# Assessment Officer Report

PA2302689 90 Alexandra Road, Ringwood East Tintern Grammar School

Officer Assessment Report Development Approvals & Design

Figure 13: Proposed sign on Gracedale Avenue

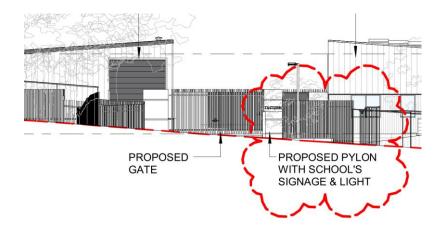
- 37. Clause 52.05 sets out the requirements for signs.
- 38. The application proposes a 0.2m x 1.0m (approx.) flood-lit business identification sign on a pillar near the entry gate on Gracedale Avenue (see Figure 12).
- 39. The sign is considered appropriate to identify the new entrance to the school. It is not dominant, will not impact views or vistas or cause visual clutter. Amenity impacts from the proposed light within the sign will be avoided due to its discrete design with the lighting incorporated into the pillar. As such the sign is supported, subject to standard conditions.
